Service Bulletin

14-070

July 1, 2015 00407-01886 Version 6

Safety Recall: Front Passenger's Airbag Inflator May Produce Excessive Pressure After Long-Term Exposure To High Absolute Humidity

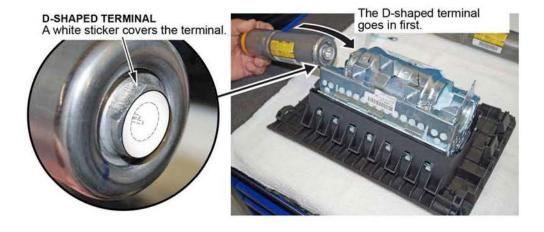
New and different inflators are available. You may receive a different part number than ordered, and the inflator may physically look different from previous replacement parts. As a result, there may be different installation instructions. Make sure you review this service bulletin for installation instructions and details about model applicability. PARTS INFORMATION and REPAIR PROCEDURE were updated to reflect these new parts.

One connector looks like a "D" whereas the other connector is a circle. Make sure you insert the "D" shaped terminal into the airbag first.

NOTE: There is a yellow band marking on the circle side.

• Slide the inflator in until the "D" aligns with the tab on the inflator bracket. There should be no space or gap between the inflator and bracket.

Reinstall the inflator bracket. There should be no space or gap between the bracket and inflator.
